Key Documents Related to the Recirculation of Portions of the Draft Environmental Impact Report

Horizon West Transmission, LLC's Original Comments on the Draft Environmental
Impact Report

Re: Comments of Horizon West Transmission, LLC on the Draft Environmental Impact Report for the Estrella Substation and Paso Robles Area Reinforcement Project, December 2020 (California State Clearinghouse No. 2018072071)

Figure 2-11.
Preliminary Substation Layout

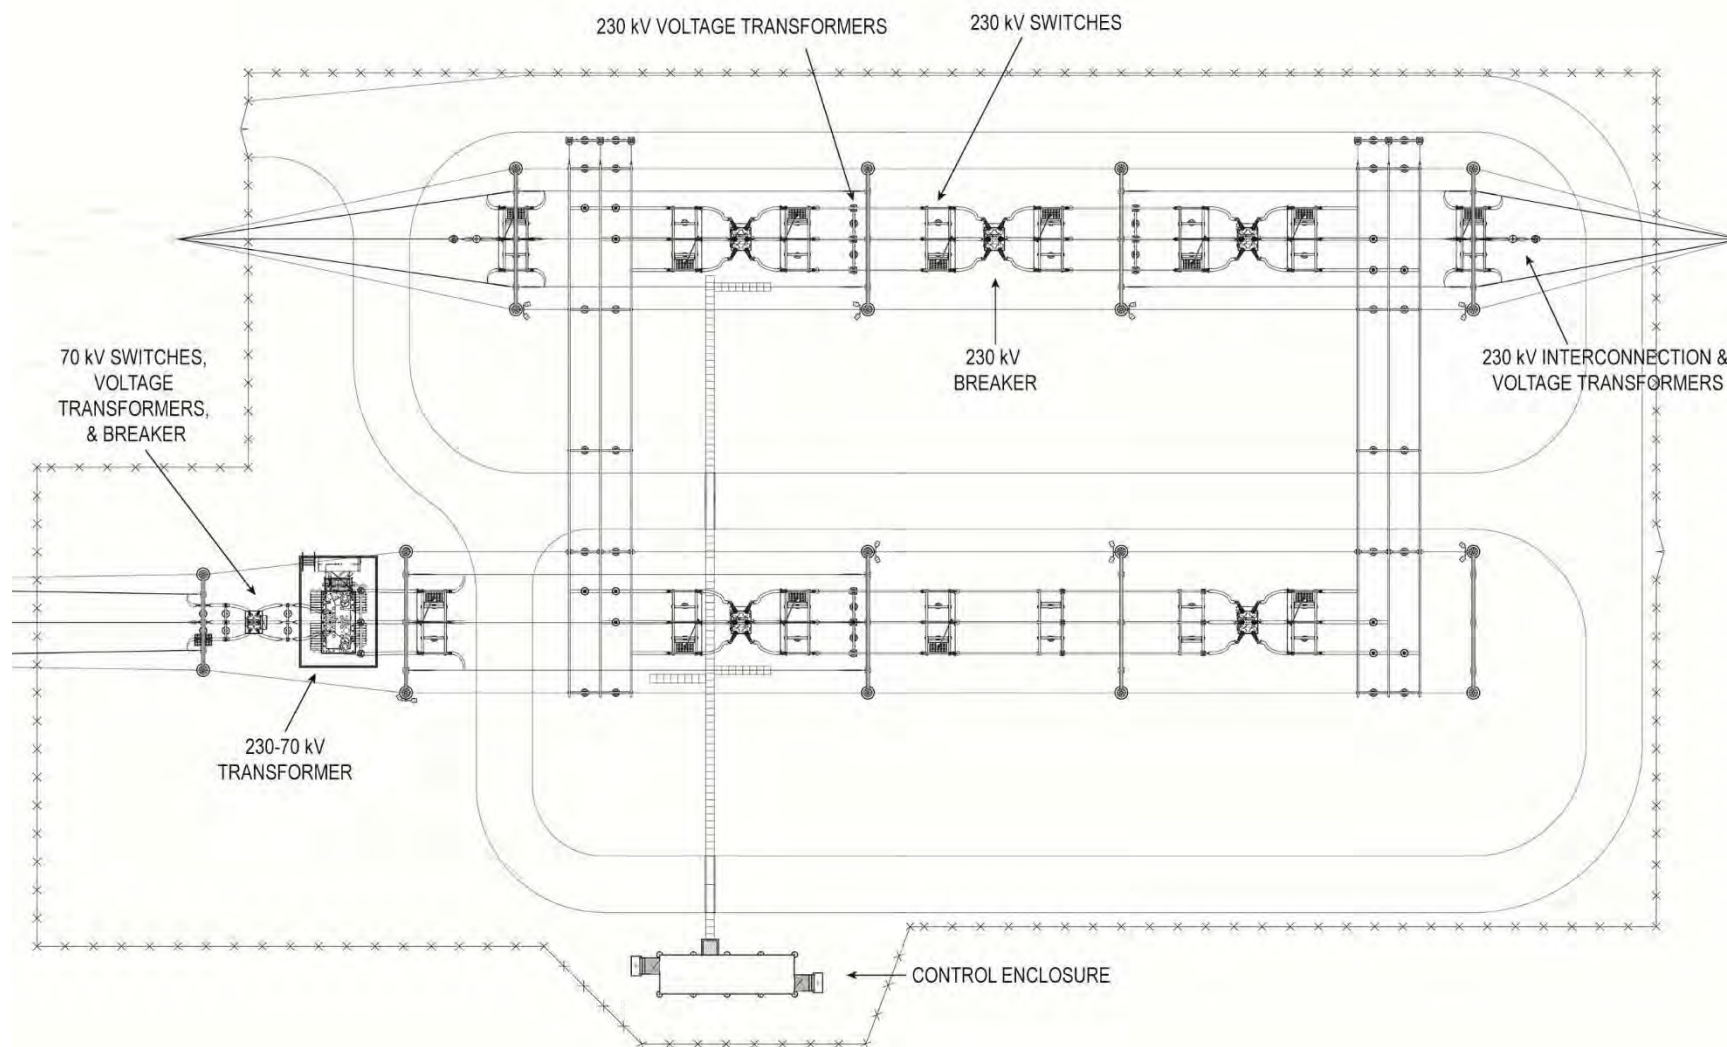
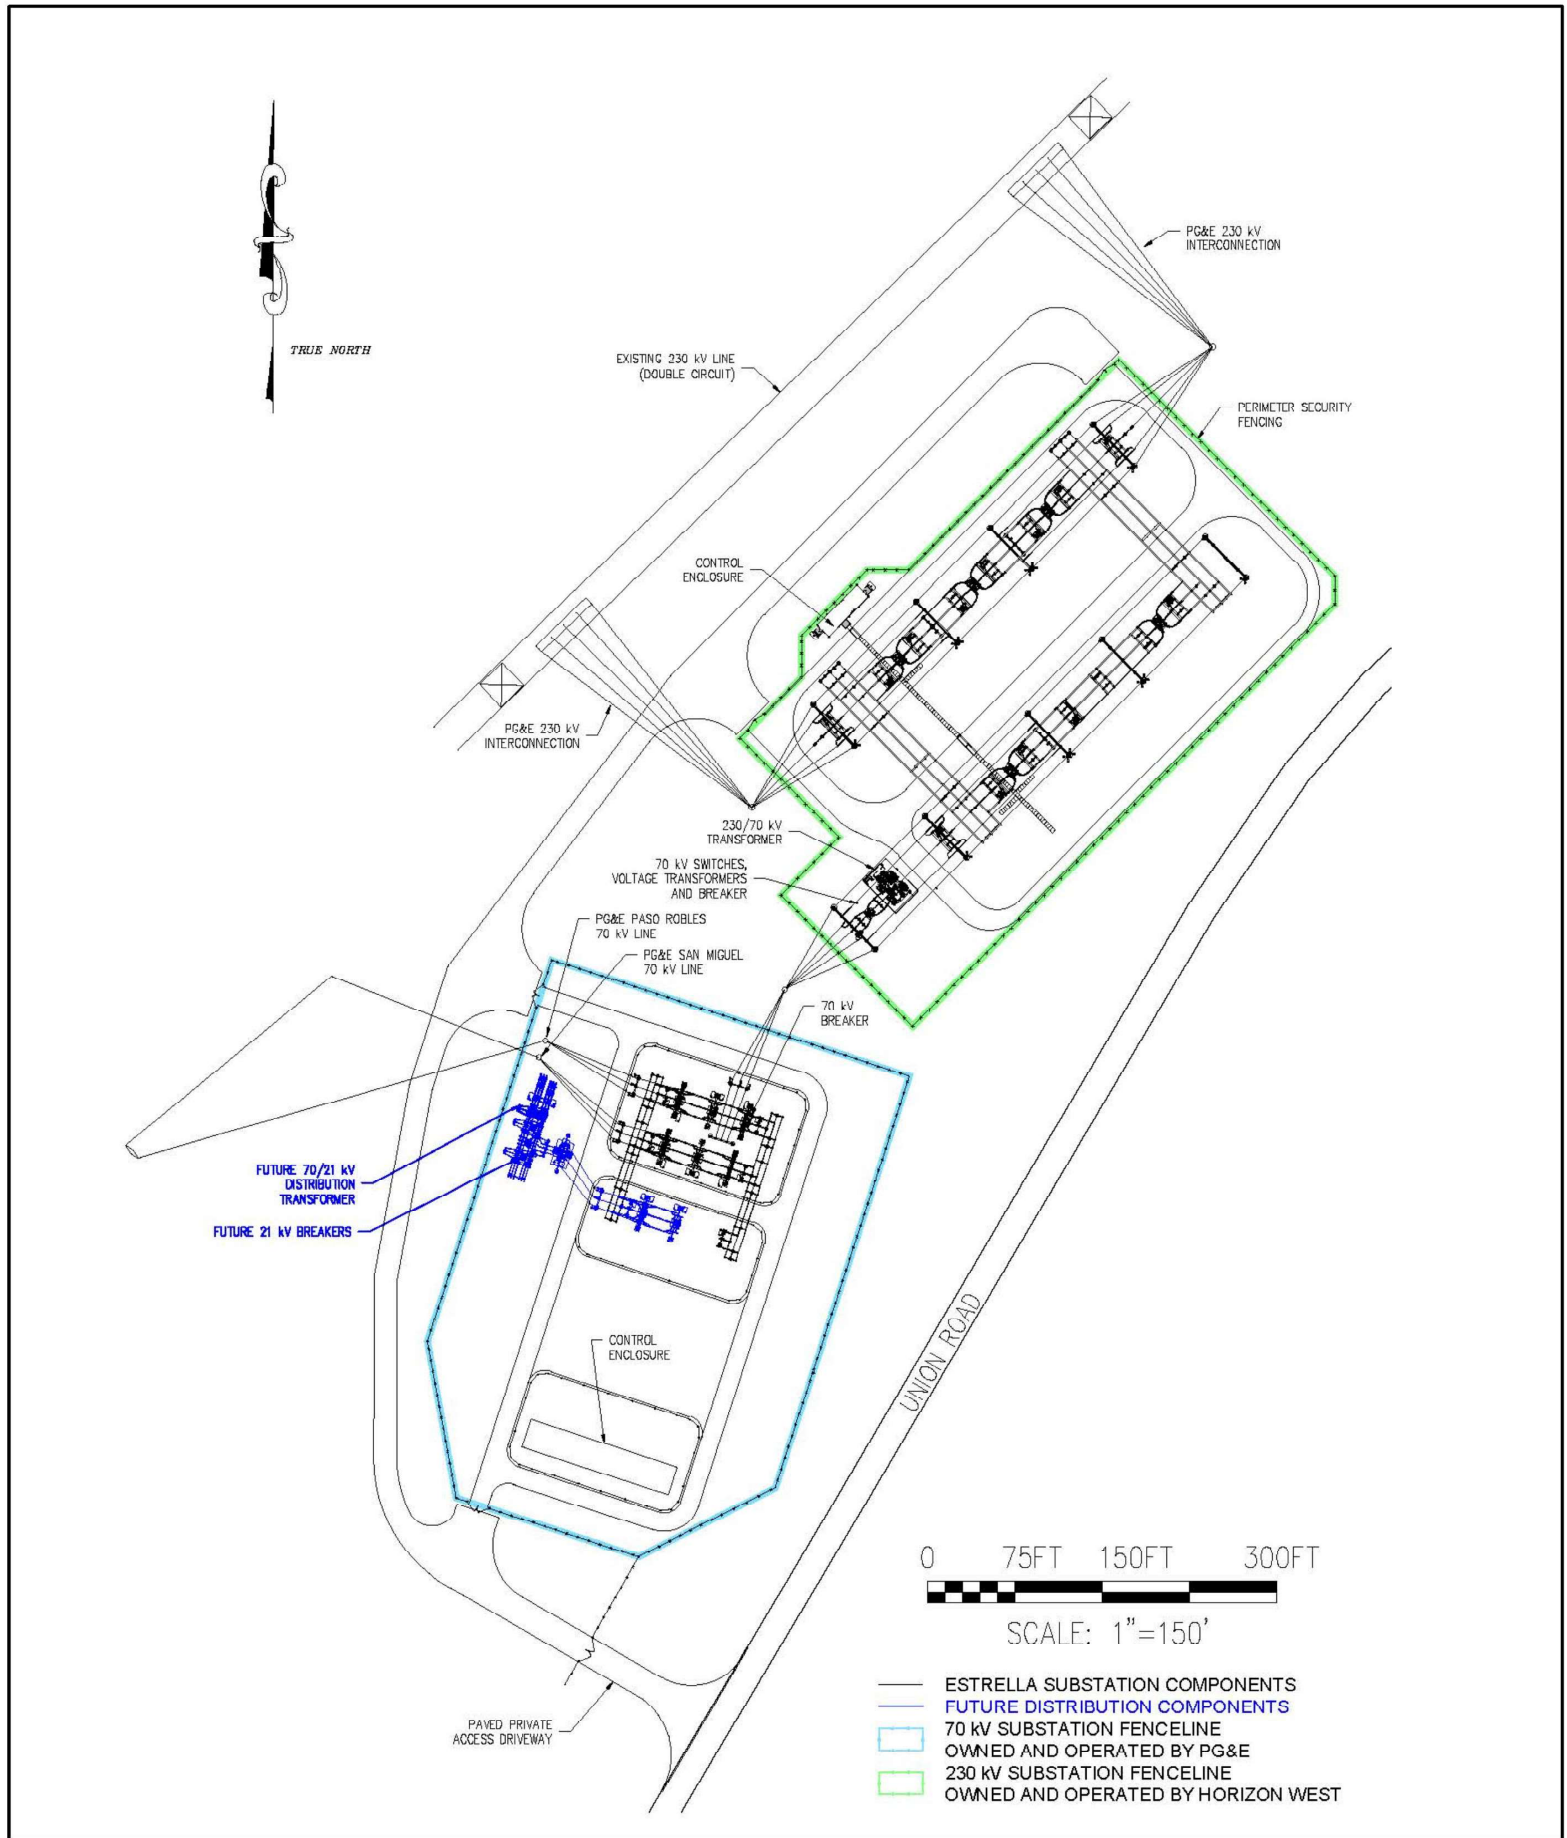
2-22	Figure 2-7	Replace figure to include new substation parcel and update temporary and permanent disturbance areas
2-46	Figure 2-11	Replace figure with new substation layout
2-47	Figure 2-12	Replace figure with new substation layout
2-48	Figure 2-13	Replace figure with new substation layout
2-49	The fenced portion of the 230 kV substation would be approximately 4 acres in size. An approximately 7-foot-tall chain-link fence with an additional 1 foot of barbed wire would be installed around the remaining perimeter of the 230 kV substation.	Please revise text to read: The fenced portion of the 230 kV substation would be approximately 4 acres in size. An approximately 7-foot-tall chain-link fence, <u>a minimum of 7 feet tall</u> , with an additional 1 foot of barbed wire would be installed around the remaining perimeter of the 230 kV substation.
2-56	The equipment and facilities associated with ultimate substation buildout would primarily be placed within the fence line of the already-constructed Estrella Substation. The anticipated layout of the Estrella Substation at ultimate buildout is shown in Figure 2-18. The additional 230/70 kV transformer under ultimate buildout is assumed to include the same amount of mineral oil (16,000 to 18,000 gallons) as described for the Proposed Project (see Section 2.3.1), and the same secondary containment structure (i.e., designed to allow sufficient freeboard to include the oil volume of the transformer plus the precipitation from a 25-year, 24-hour storm event). The additional 230 kV interconnection is assumed to include similar structures (LSTs) and follow a similar interconnection process to that described for the Proposed Project in Section 2.3.1 under the header for “230 kV Transmission Interconnection.” The additional 70/21 kV transformers that may be installed to support additional distribution feeders are assumed to include secondary containment, as necessary to contain spills of any stored mineral oil.	Please revise text to read: The equipment and facilities associated with ultimate substation buildout would primarily be placed within the fence line of the already-constructed Estrella Substation. The anticipated layout of the Estrella Substation at ultimate buildout is shown in Figure 2-18. The additional 230/70 kV transformer under ultimate buildout is assumed to include the same amount of mineral oil (16,000 to 18,000 gallons) as described for the Proposed Project (see Section 2.3.1), and the same secondary containment structure (i.e., designed to allow sufficient freeboard to include the oil volume of the transformer plus the precipitation from a 25-year, 24-hour storm event). The additional 230 kV interconnection is assumed to include similar structures (LSTs) and follow a similar interconnection process to that described for the Proposed Project in Section 2.3.1 under the header for “230 kV Transmission Interconnection.” The additional 70/21 kV transformers that may be installed to support additional distribution feeders are assumed to include secondary containment, as necessary to contain spills of any stored mineral oil.

Figure 2-12.
Proposed 230 Kilovolt Substation General Arrangement

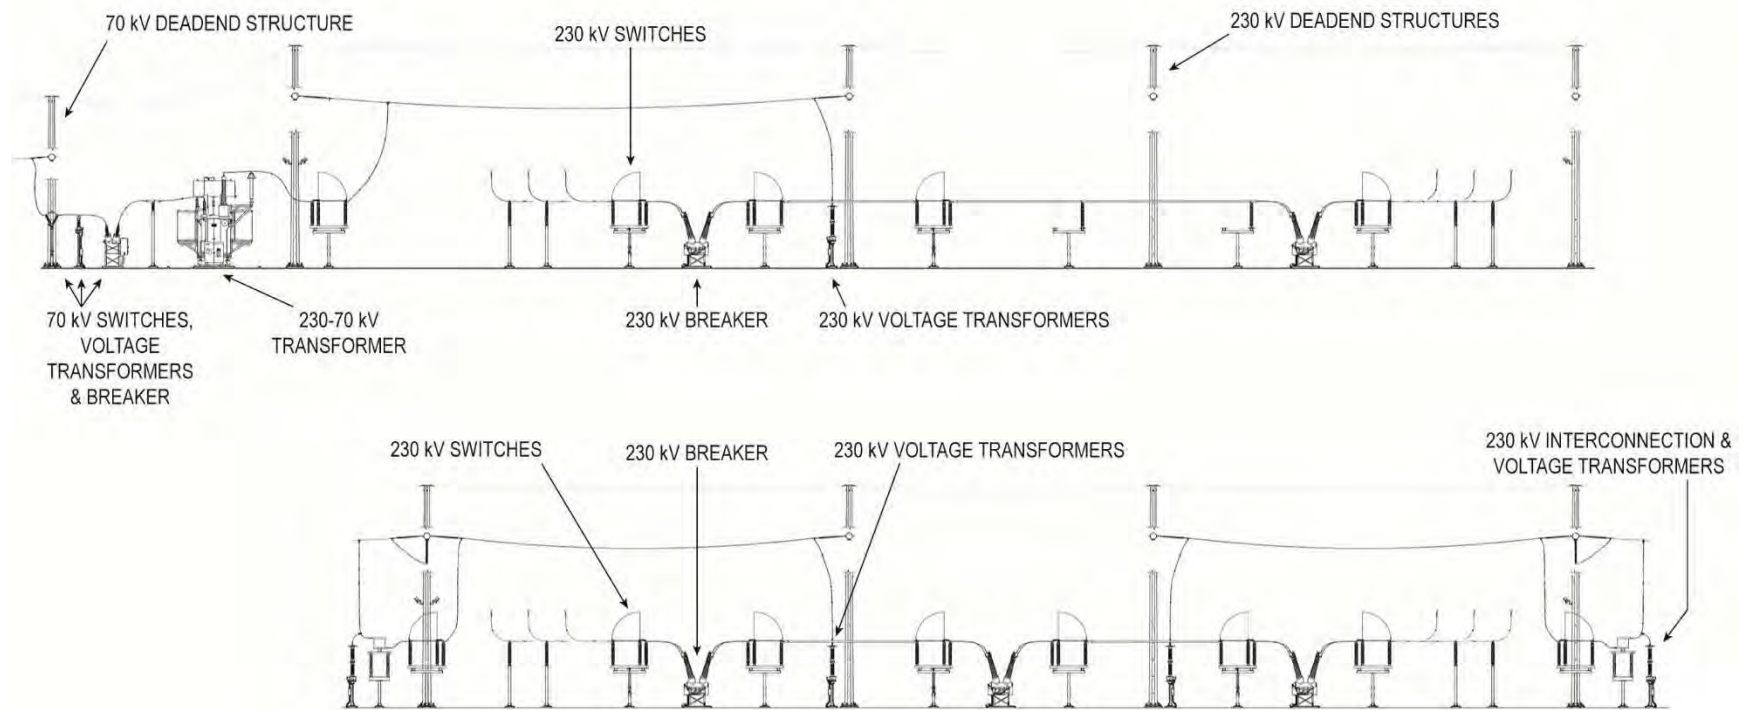
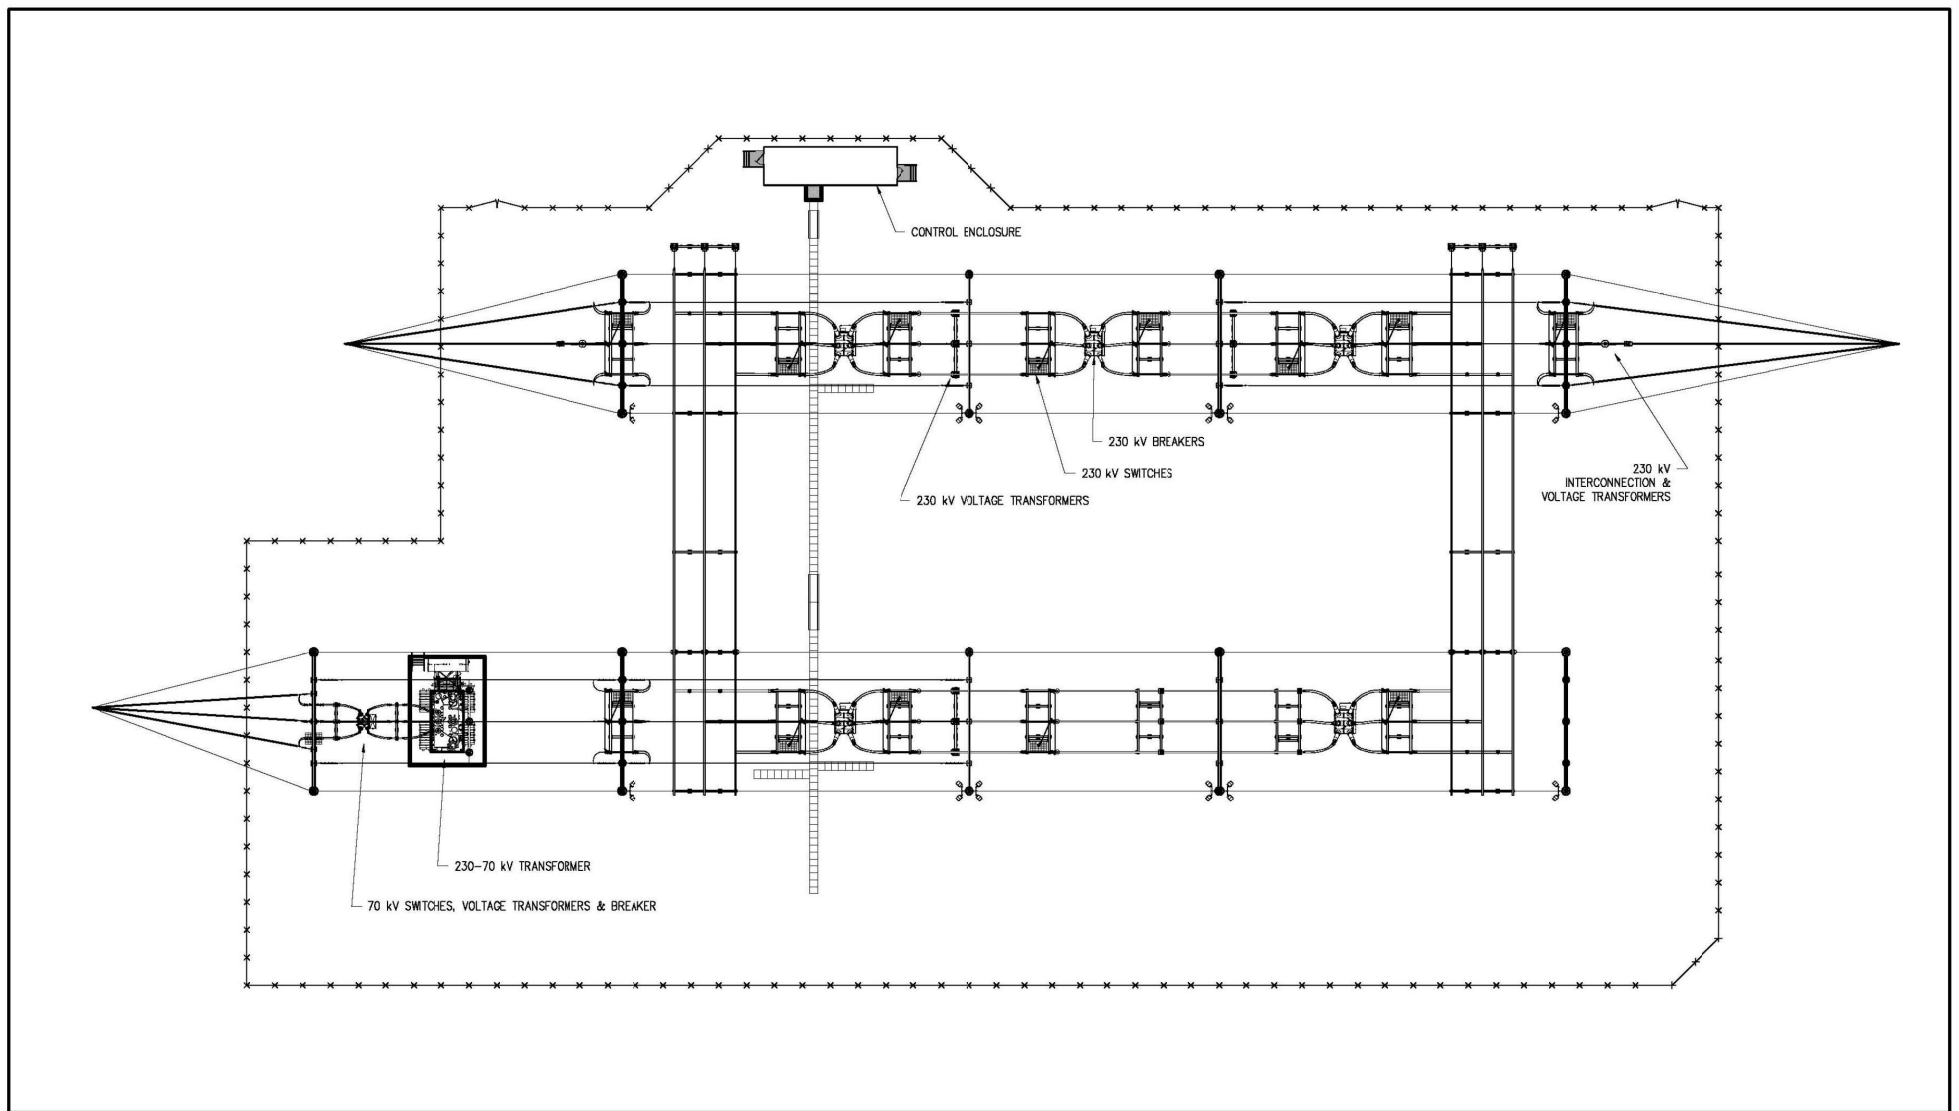
2-47	Figure 2-12	Replace figure with new substation layout
2-48	Figure 2-13	Replace figure with new substation layout
2-49	The fenced portion of the 230 kV substation would be approximately 4 acres in size. An approximately 7-foot-tall chain-link fence with an additional 1 foot of barbed wire would be installed around the remaining perimeter of the 230 kV substation.	Please revise text to read: The fenced portion of the 230 kV substation would be approximately 4 acres in size. A approximately 7-foot-tall chain-link fence, <u>a minimum of 7 feet tall</u> , with an additional 1 foot of barbed wire would be installed around the remaining perimeter of the 230 kV substation.
2-56	The equipment and facilities associated with ultimate substation buildout would primarily be placed within the fence line of the already-constructed Estrella Substation. The anticipated layout of the Estrella Substation at ultimate buildout is shown in Figure 2-18. The additional 230/70 kV transformer under ultimate buildout is assumed to include the same amount of mineral oil (16,000 to 18,000 gallons) as described for the Proposed Project (see Section 2.3.1), and the same secondary containment structure (i.e., designed to allow sufficient freeboard to include the oil volume of the transformer plus the precipitation from a 25-year, 24-hour storm event). The additional 230 kV interconnection is assumed to include similar structures (LSTs) and follow a similar interconnection process to that described for the Proposed Project in Section 2.3.1 under the header for "230 kV Transmission Interconnection." The additional 70/21 kV transformers that may be installed to support additional distribution feeders are assumed to include secondary containment, as necessary to contain spills of any stored mineral oil.	Please revise text to read: The equipment and facilities associated with ultimate substation buildout would primarily be placed within the fence line of the already-constructed Estrella Substation. The anticipated layout of the Estrella Substation at ultimate buildout is shown in Figure 2-18. The additional 230/70 kV transformer under ultimate buildout is assumed to include the same amount of mineral oil (16,000 to 18,000 gallons) as described for the Proposed Project (see Section 2.3.1), and the same secondary containment structure (i.e., designed to allow sufficient freeboard to include the oil volume of the transformer plus the precipitation from a 25-year, 24-hour storm event). The additional 230 kV interconnection is assumed to include similar structures (LSTs) and follow a similar interconnection process to that described for the Proposed Project in Section 2.3.1 under the header for "230 kV Transmission Interconnection." The additional 70/21 kV transformers that may be installed to support additional distribution feeders are assumed to include secondary containment, as necessary to contain spills of any stored mineral oil.
